## Addendum No. 1

**Project:** CM Bldg. 3 Roof Repair  
**State Job No.:** 2023-614  
**Issue Date:** 07-23-2024  
**To:** All Plan Holders  
**From:** Sara Rickards, RA

SHEET NO.  
**A-161**  
ROOF PLAN

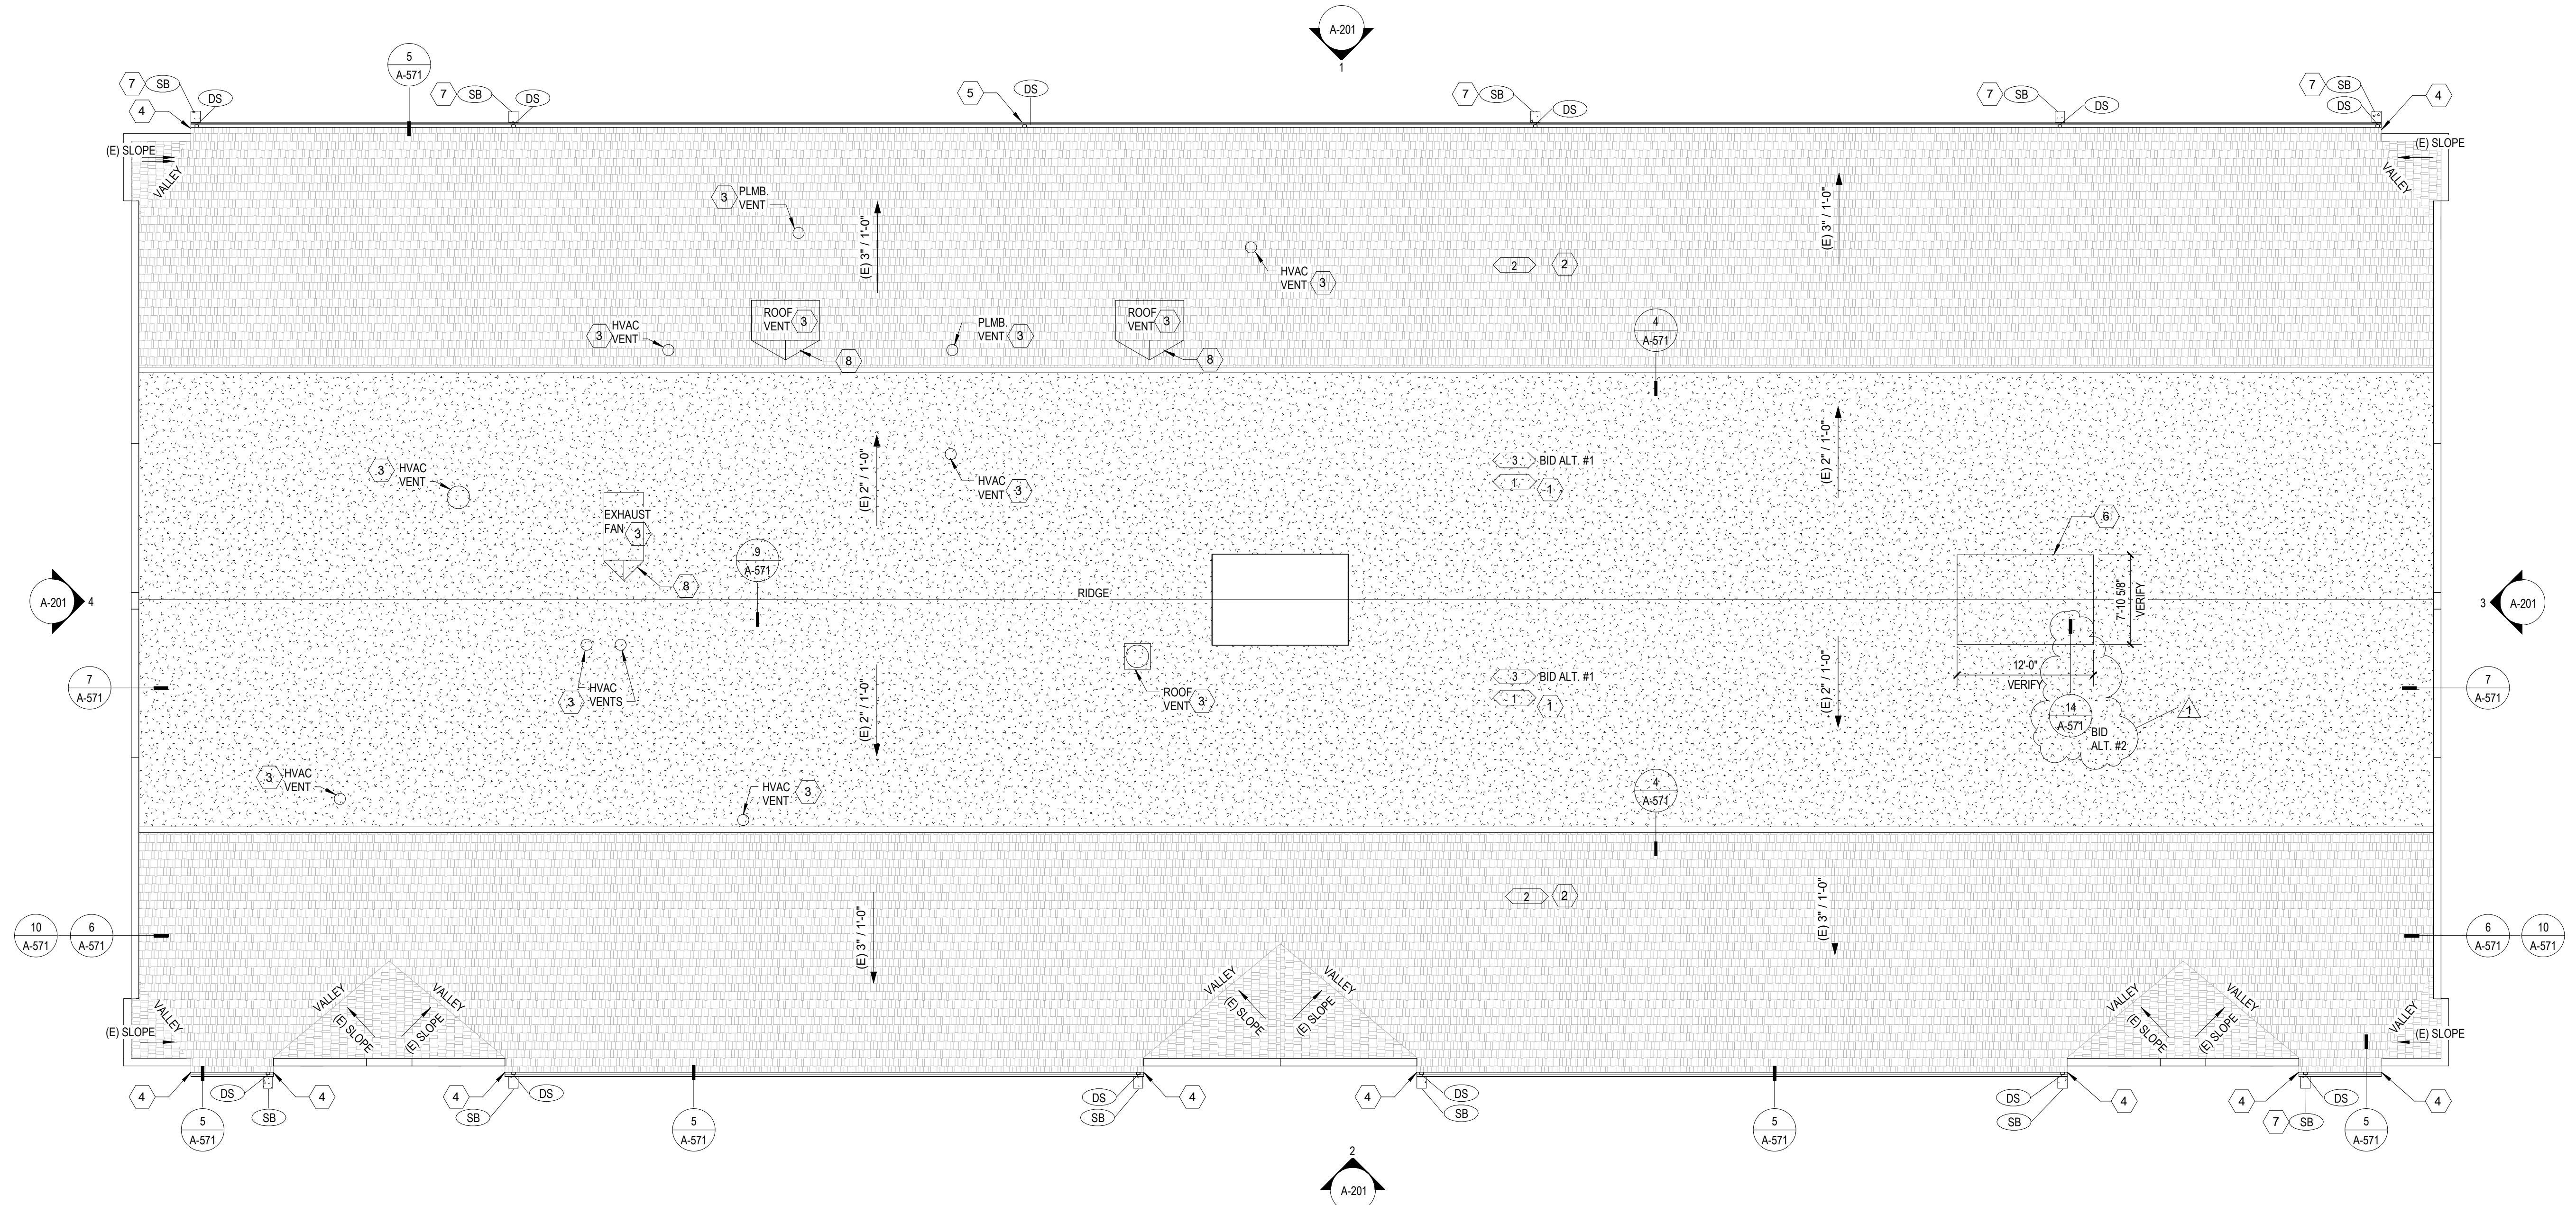
- K. **QUESTION:** On the demo roof plan keynote 5 it states to protect the existing skylight.....does this mean it will stay as is and no change will be required? Because on the roof plan it directs me to detail 14/A-571 Bid Alt#2, I just some clarification on these details.

#### 5. A-161 ROOF PLAN –

- 1) Detail callout 14/A-571 moved to the project east skylight opening.

**ANSWER:** That was an error, the tag has been moved to the existing skylight opening to project east.

CONSTRUCTION DOCUMENTS  
SHEET NO.  
**AD101**  
DEMOLITION ROOF PLAN

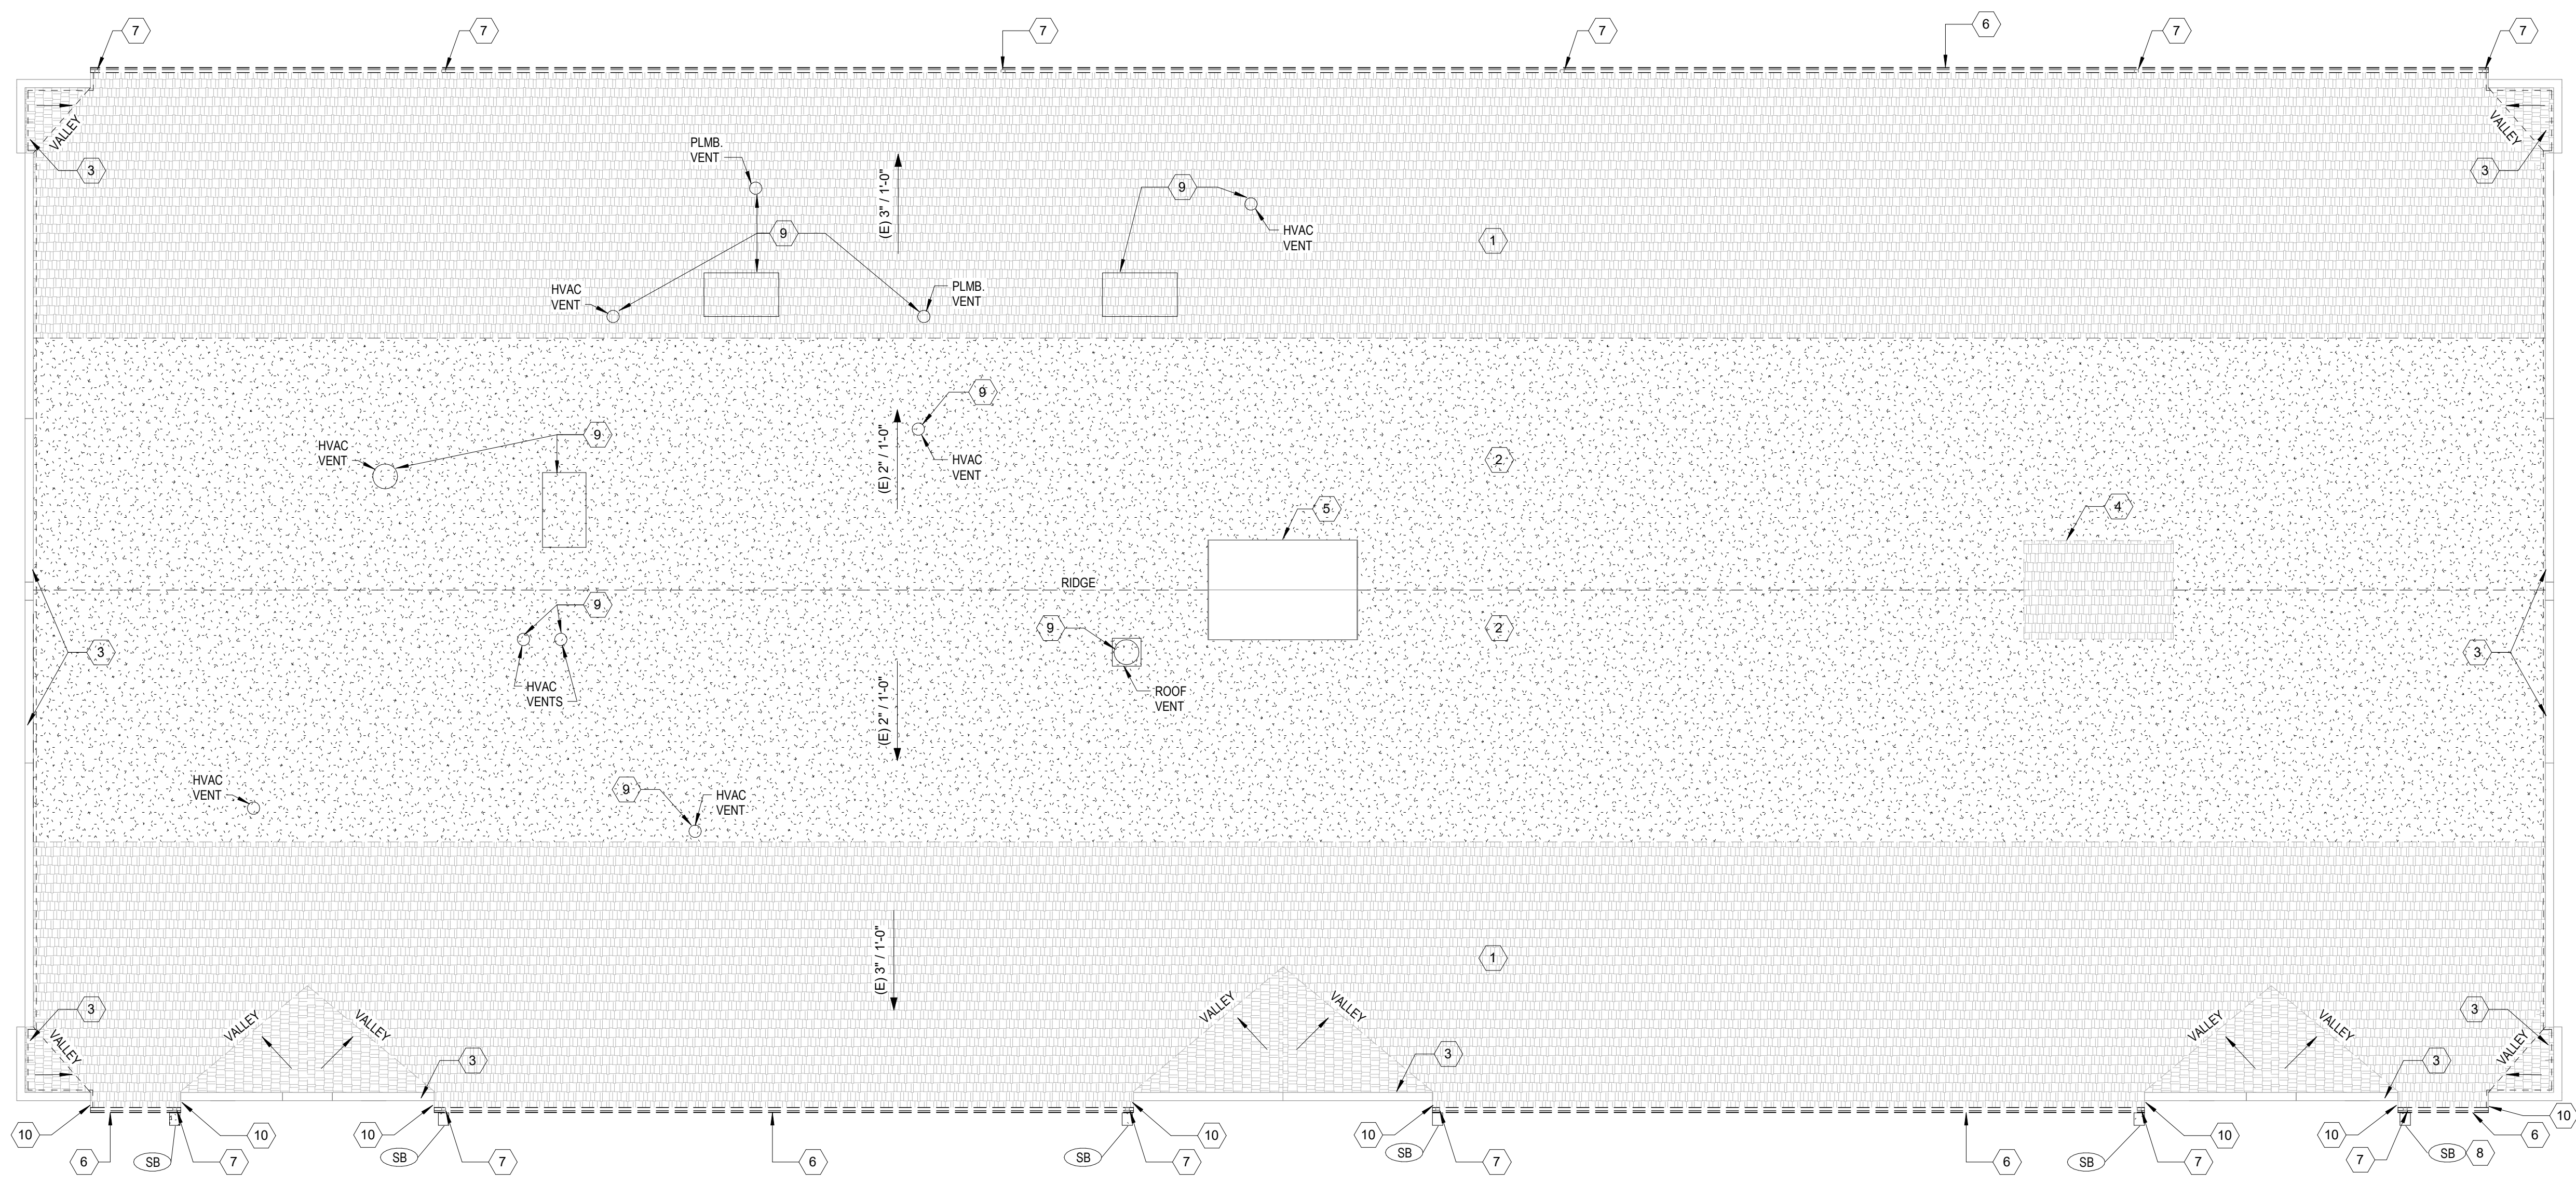
- A. **QUESTION:** Can the gutters be continuous 6" K style?  
**ANSWER:** 6" K style is acceptable. Gutters to be fabricated in no more than 50 ft. sections.
- B. **QUESTION:** Detail 5/A-571 notes fascia boards at eaves? However, the demolition and general notes only call out replacing the gable fascia boards.  
**ANSWER:** Demo notes have been updated per this Addendum to clarify fascia boards at eaves are to be replaced.
- C. **QUESTION:** Is there interior finish work required to patch the existing sky light hole as drawn?  
**ANSWER:** No, only structural work is required.
- D. **QUESTION:** Is the DBIDS Pre-Enrollment Application sufficient for the rest of the team, or do we need to do something different?  
**ANSWER:** All visitors, contractors, etc., should go through the DBIDS Pre-Enrollment Application process.
- E. **QUESTION:** Is there a Contractor Pass we can apply for?

#### 4. AD101 DEMOLITION ROOF PLAN -

- 1) Replace in entirety to include key note #10

- 1 EXISTING ROOFING: REMOVE & PROPERLY DISPOSE OF EXISTING ASPHALT SHINGLES AND ROOFING UNDERLAYMENT TO WOOD SHEATHING. ONLY REMOVE AS MUCH ROOFING AS CAN BE DRIED-IN PRIOR TO LEAVING THE SITE EACH DAY.
- 2 EXISTING ROOFING: REMOVE & PROPERLY DISPOSE OF EXISTING ASPHALT TORCH DOWN MEMBRANE TO WOOD SHEATHING. ONLY REMOVE AS MUCH ROOFING AS CAN BE DRIED-IN PRIOR TO LEAVING THE SITE EACH DAY.
- 3 FLASHINGS: REMOVE AND PROPERLY DISPOSE OF ALL SHEET METAL COPINGS, WALL, EDGE AND MISC. FLASHING, UON.
- 4 REMOVE COVER AND FLASHING AND CURB FROM SKYLIGHT OPENING. SEE DETAILS FOR INFILL OF OPENING.
- 5 PROTECT EXISTING SKYLIGHT IN PLACE
- 6 REMOVE ALL GUTTERS
- 7 SALVAGE AND REUSE ALL DOWNSPOUTS
- 8 REMOVE DAMAGED SPLASH BLOCK
- 9 SALVAGE AND REUSE ALL PLMB. & MECH. VENTS. TAKE CARE TO REMOVE AND REPLACE ALL FLASHINGS.
- 10 FACIA BOARDS AT EAVES TO BE REPLACED
